Ground Floor Flat
5 Hillfield Road
London NW6 1QD

Re: Planning Reference 2021/2596/P

**Description: Site R/0 1 Hillfield Road NW6 – OBJECTION TO APP 2021/2596/P
OBJECTION BY 5 HILLFIELD ROAD – OVERSHADOWING ADDENDUM**

**Site Address: Land between Gondar House and South Mansions, Gondar
Gardens and to the rear of Hillfield Road, West Hampstead, London NW6 1QD.**

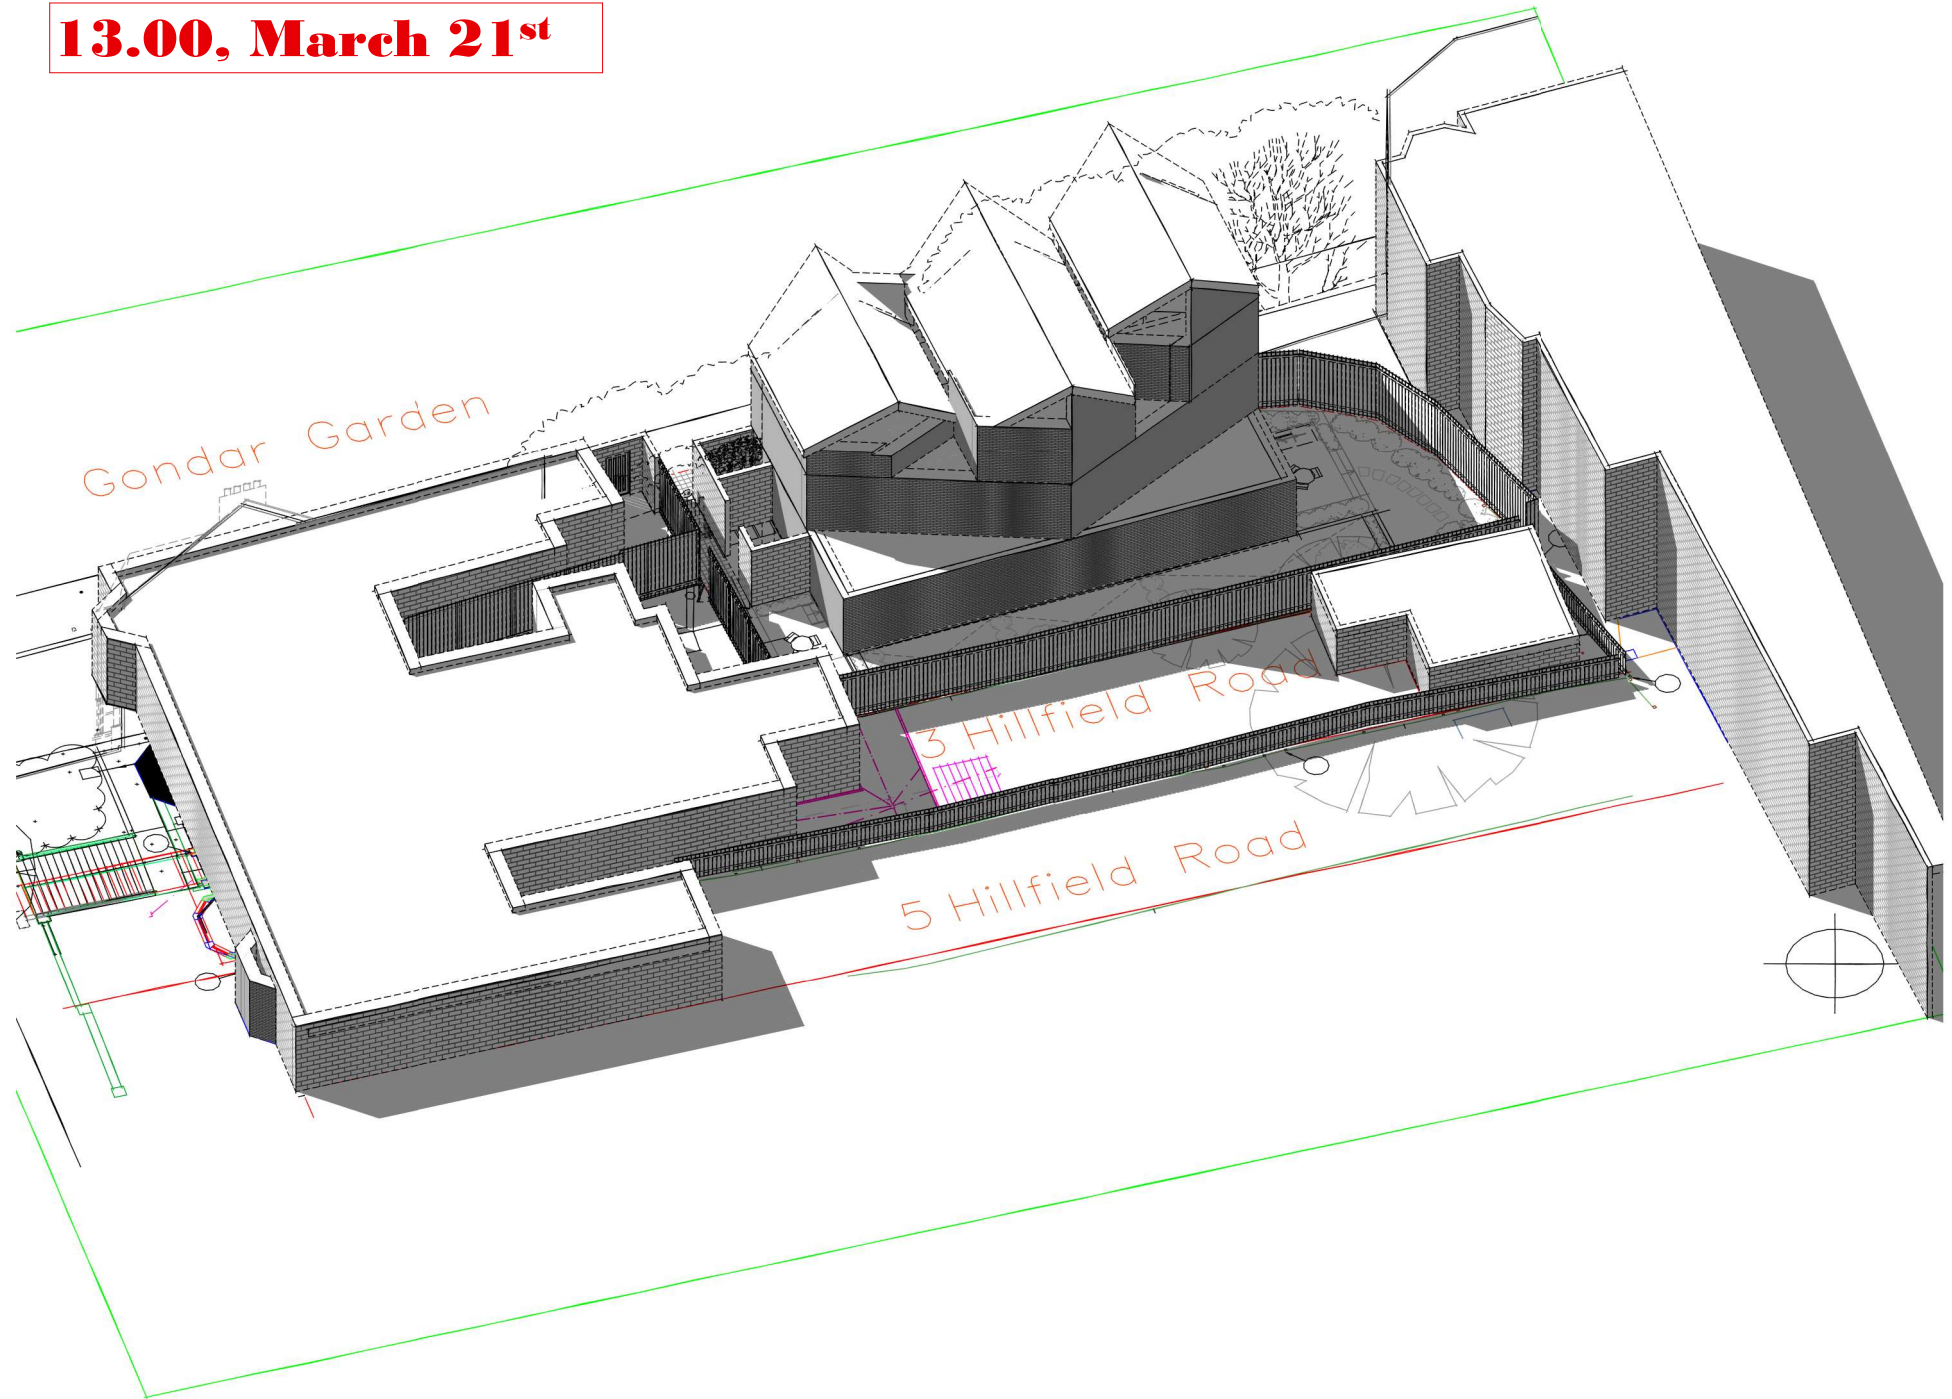
Our own modelling has Gondar House only as ground floor as such the modelling does not show full height of the building and hence not the correct overshadowing on 1 Hillfield Road patio area which will be much worse than the current modelling. The modelling was done to show the extent of overshadowing on 3,5 & 7 Hillfield Road gardens. Also, our model below shows the overshadowing at 21 March. The model shows that the sun is blocked from 14:00 o'clock on 3 Hillfield Road and from 15:00 it is blocking 5 Hillfield Road, the overshadowing continues till sunset at 18:15. We went further to do analysis in June and the overshadowing continues till sunset at 21:00.

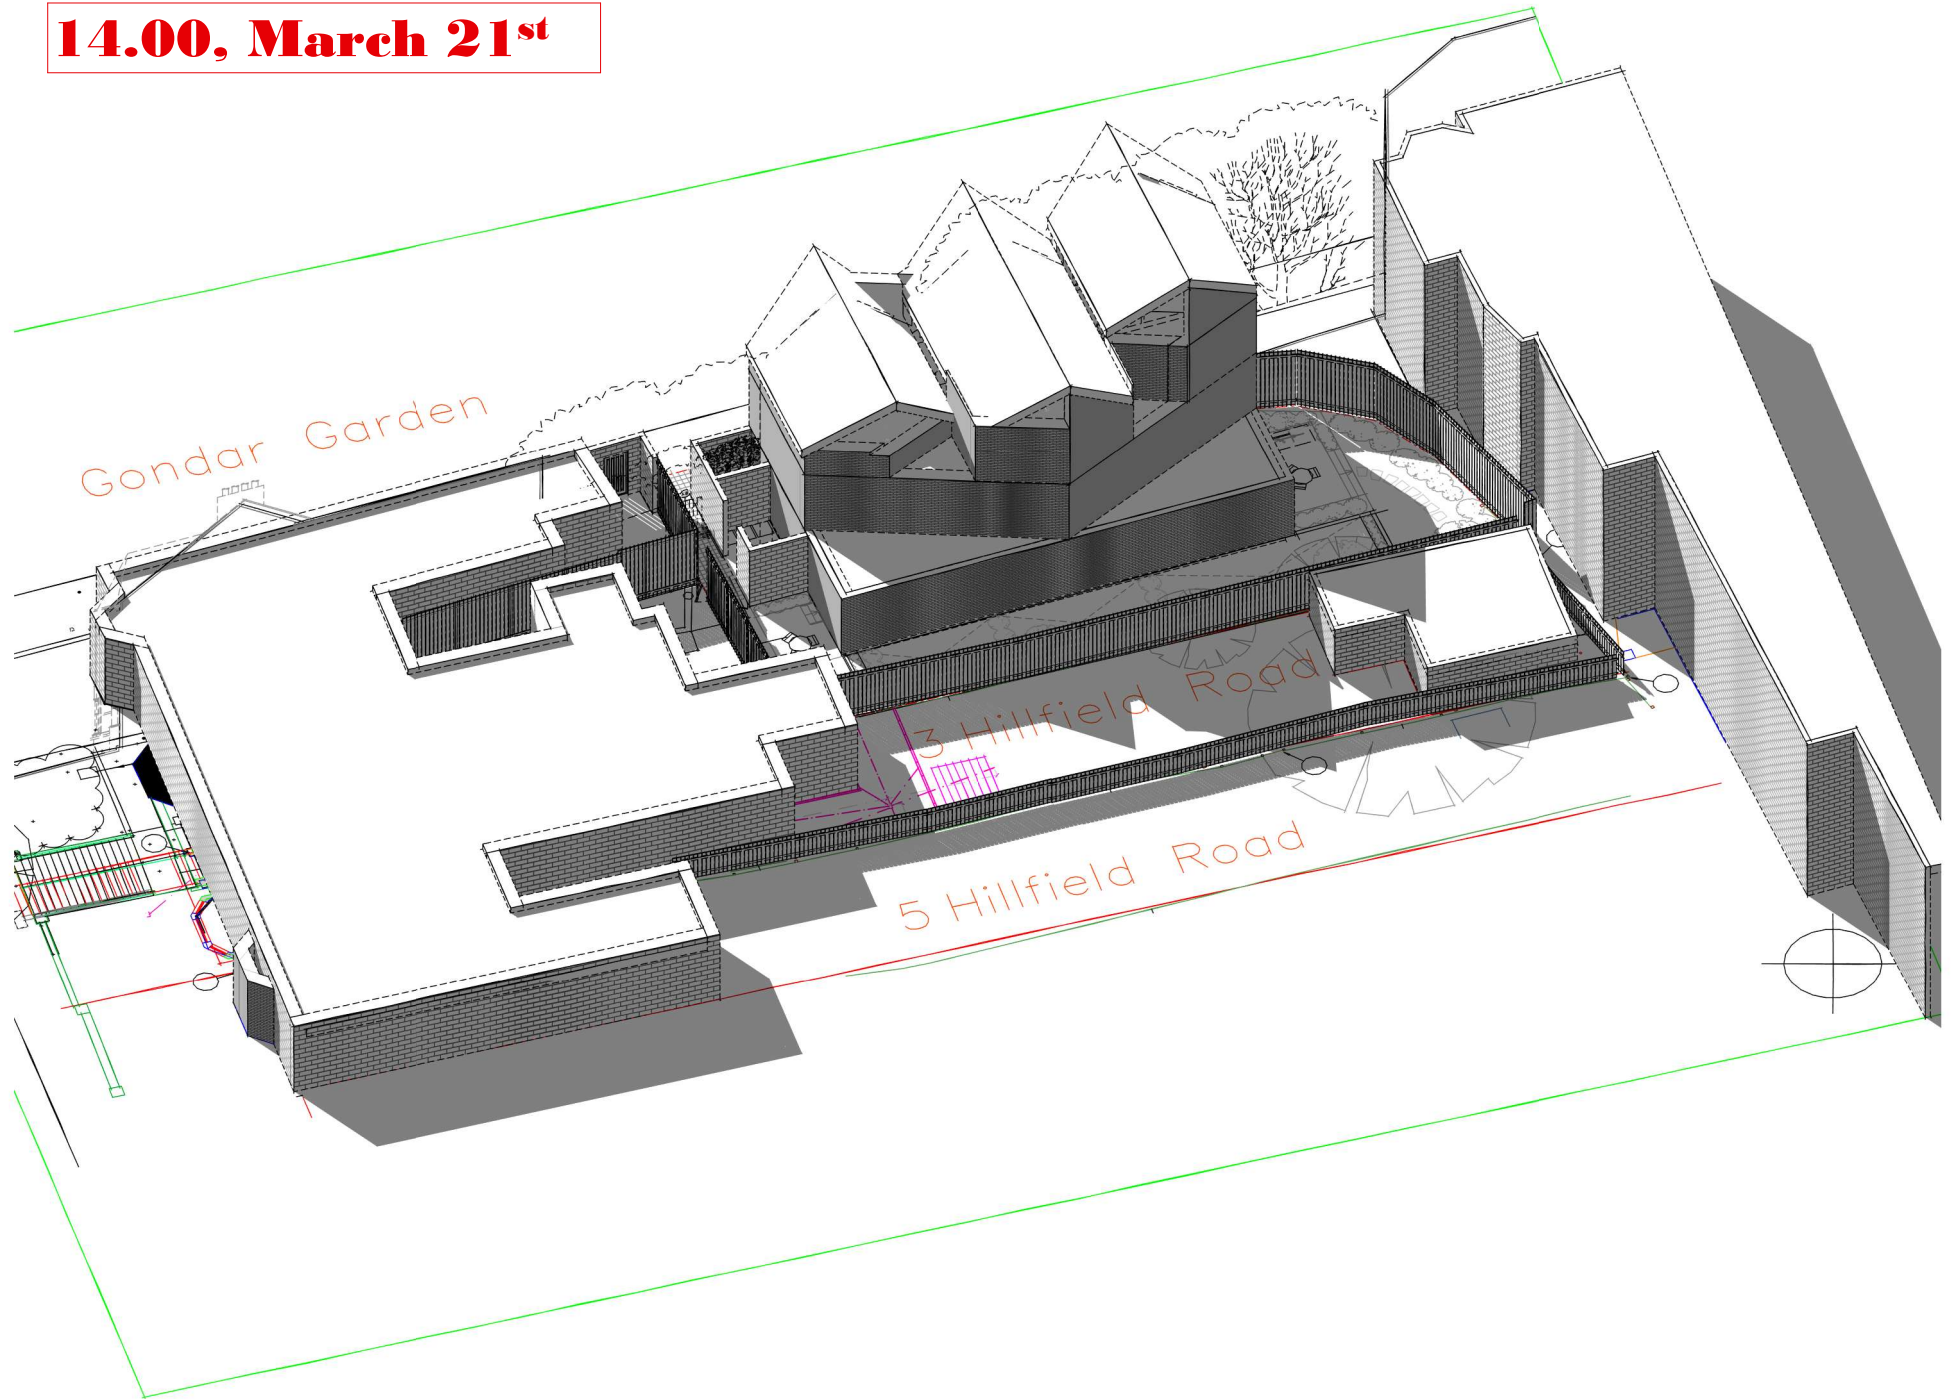
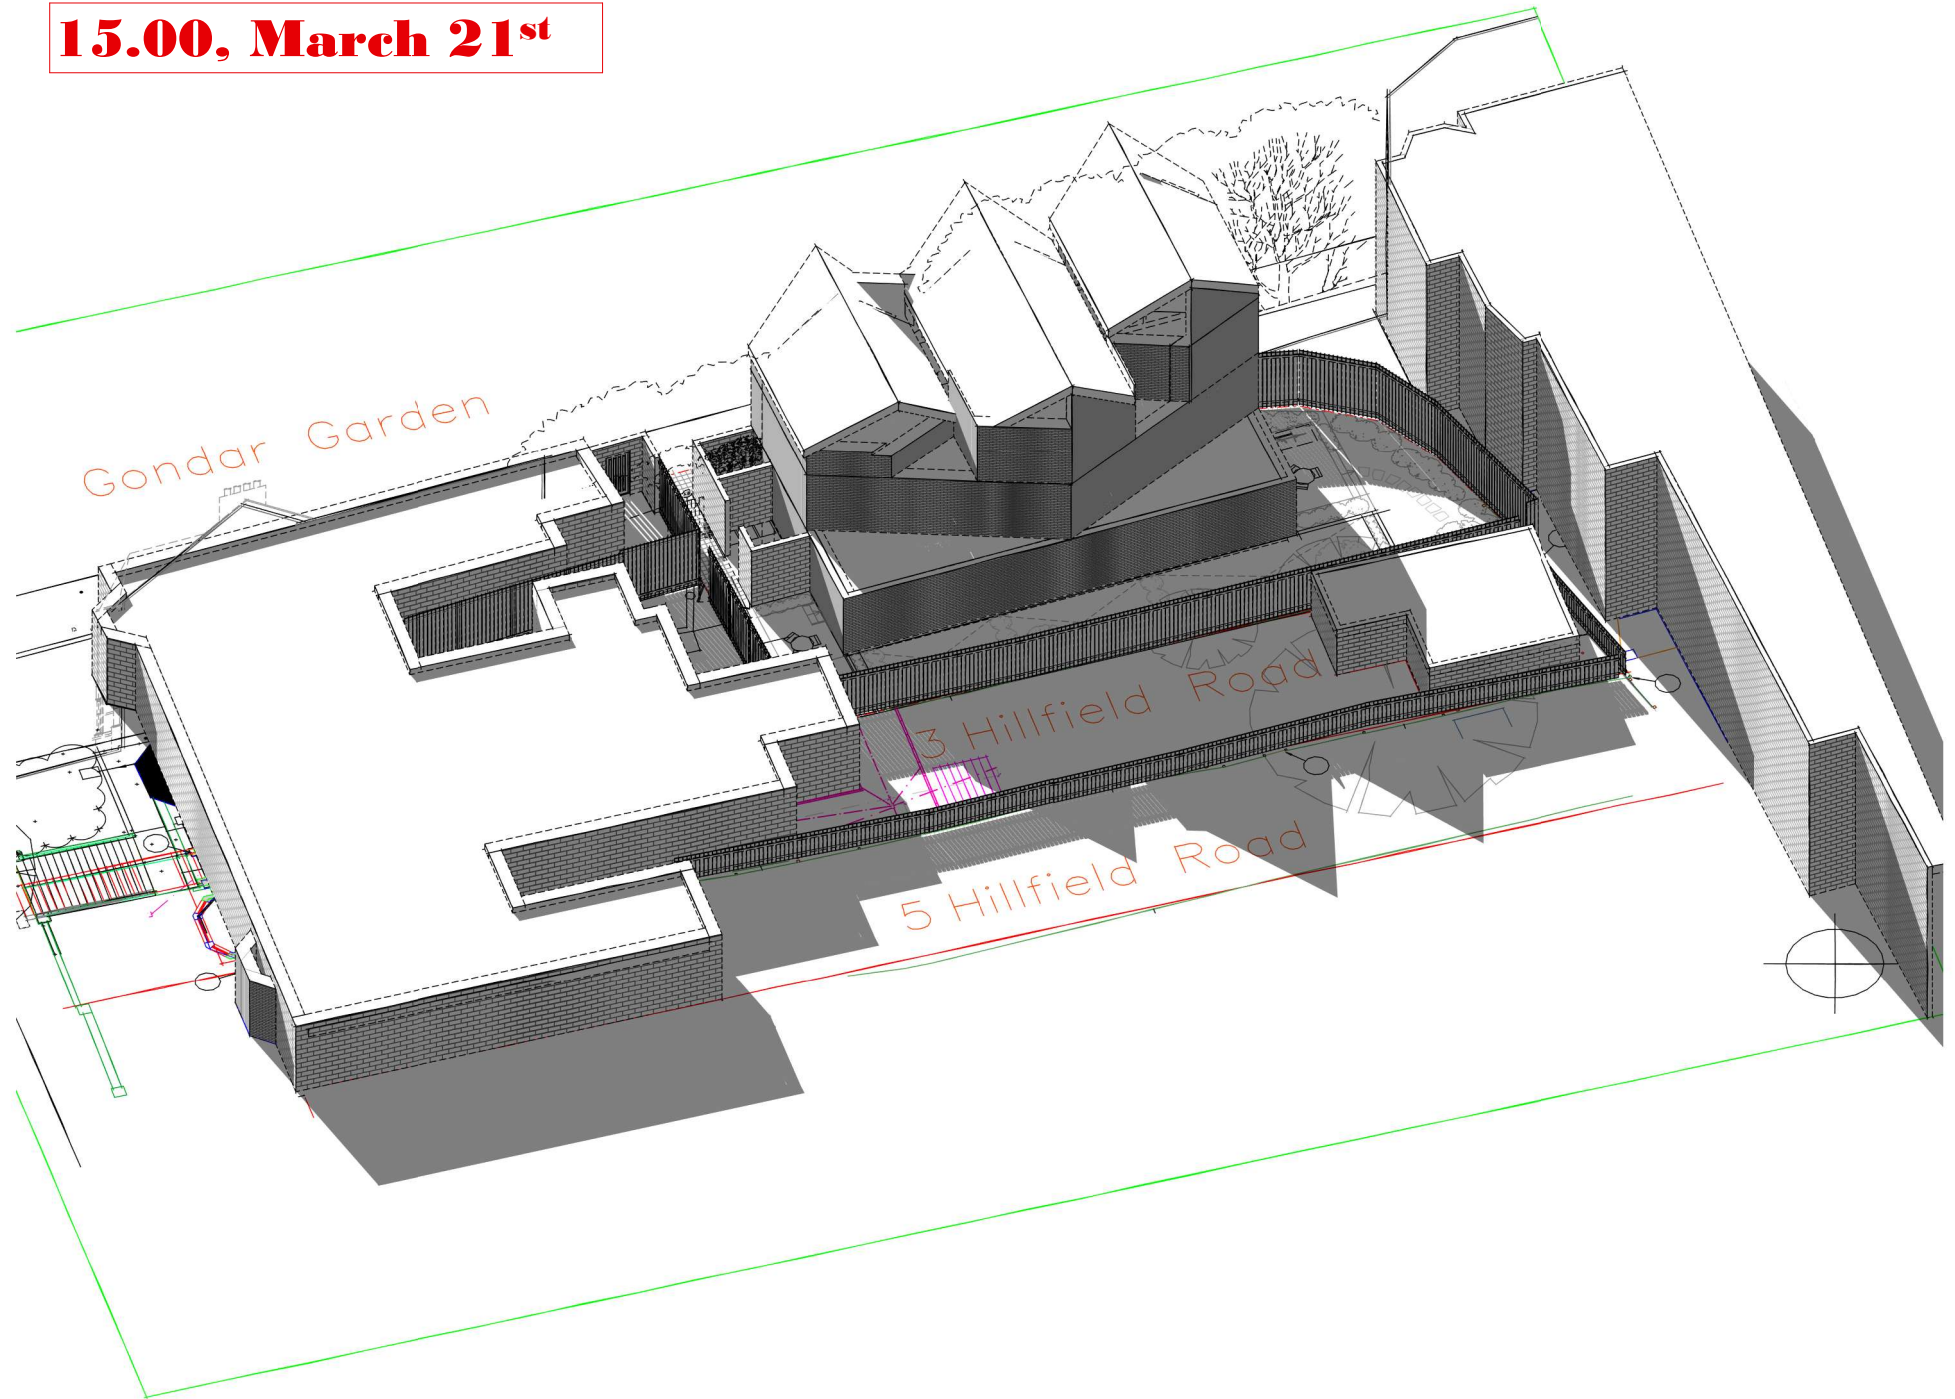
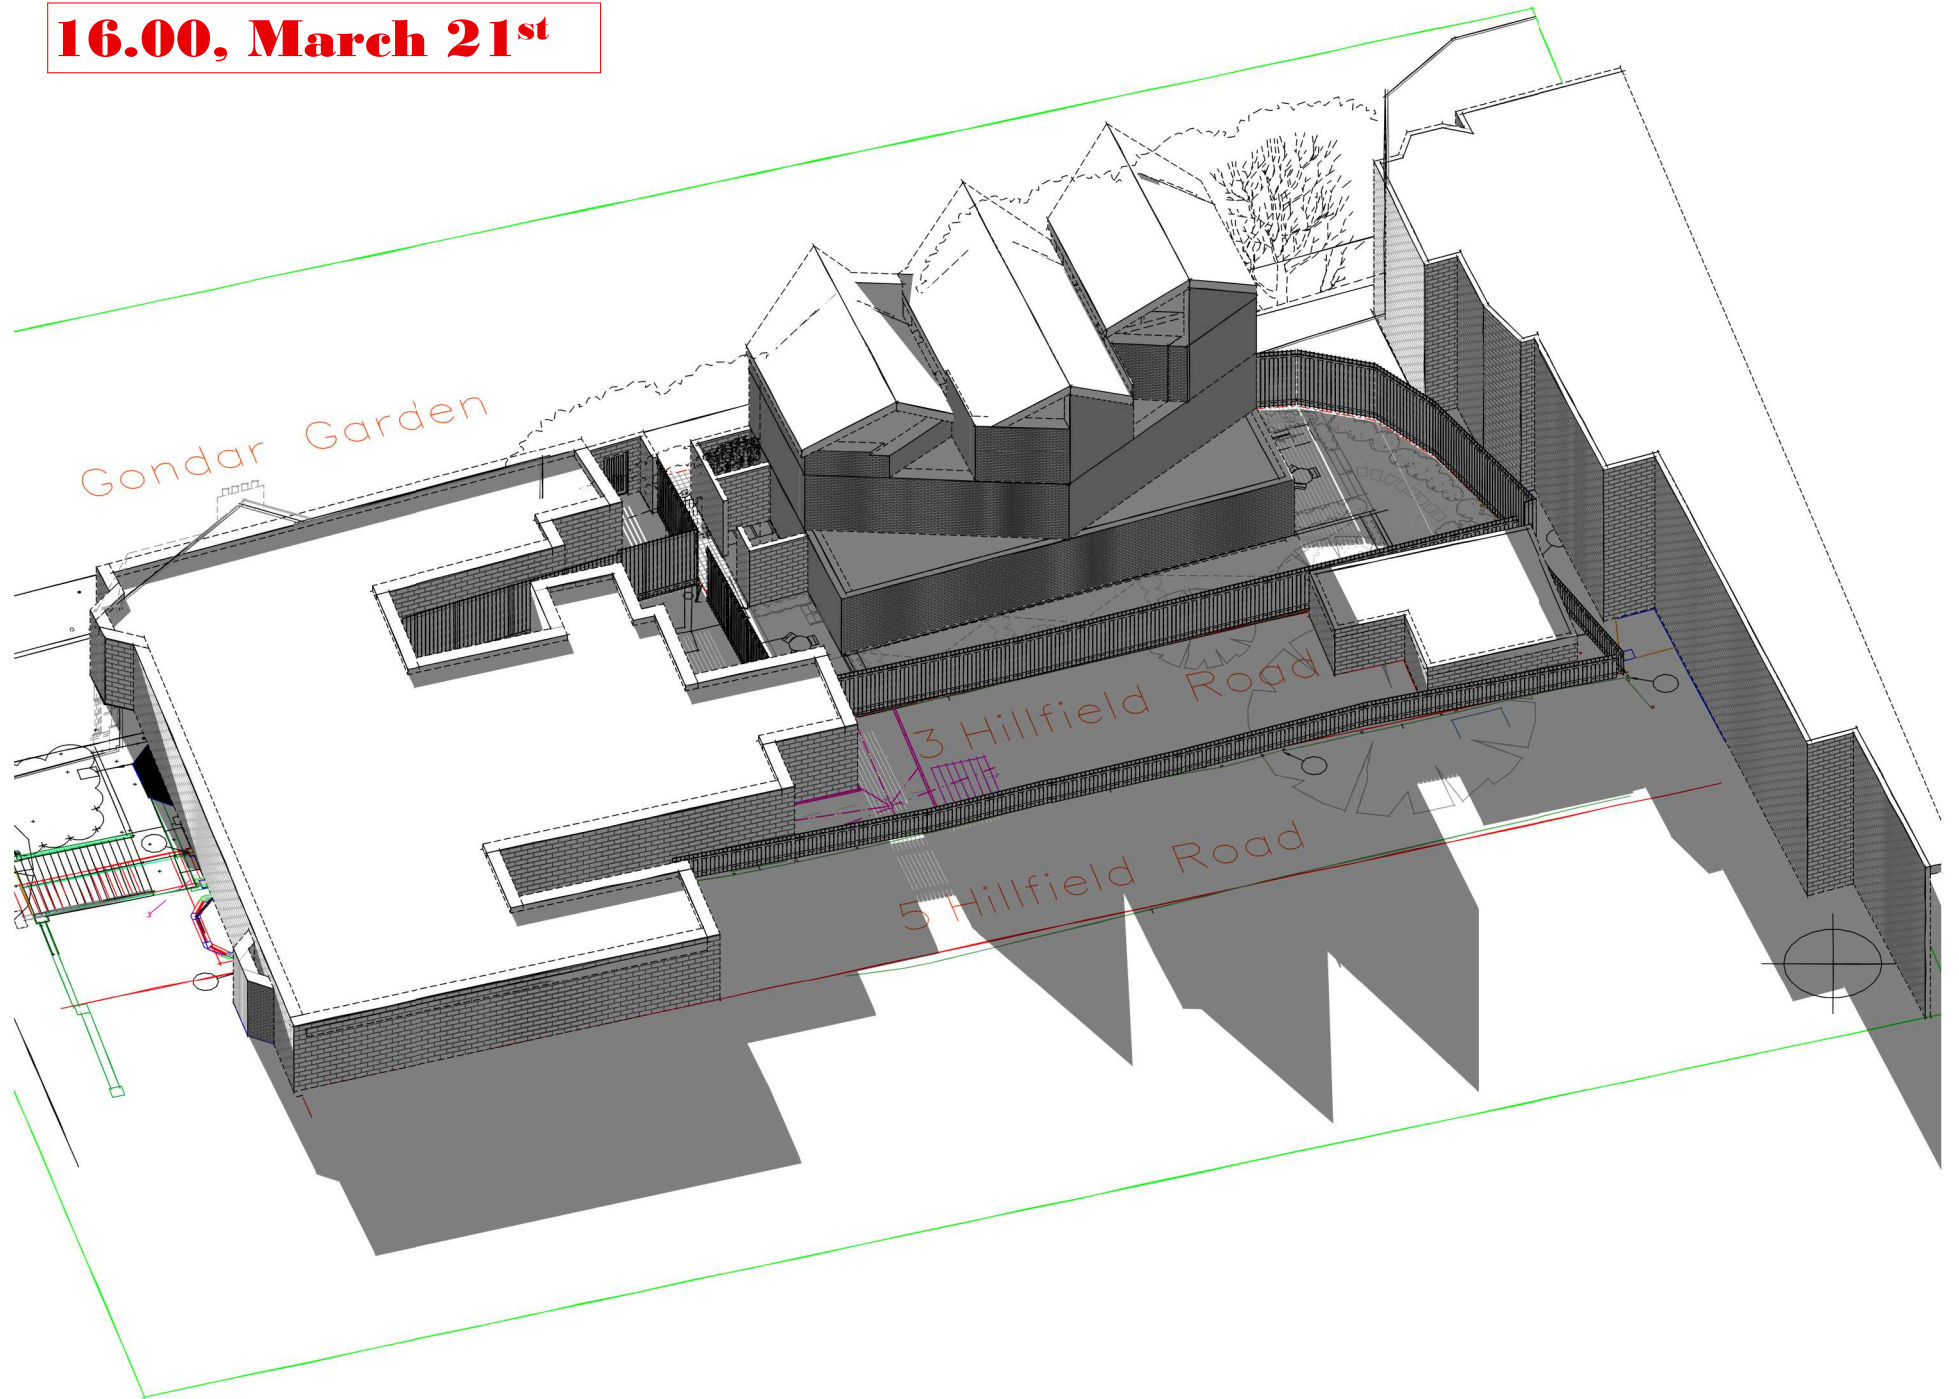
From the analysis we have carried out below the development clearly does not meet the criteria above and development sheer size blocks all the sunlight completely into the gardens of 3 and 5 Hillfield Road. It also affects 7 Hillfield Road.
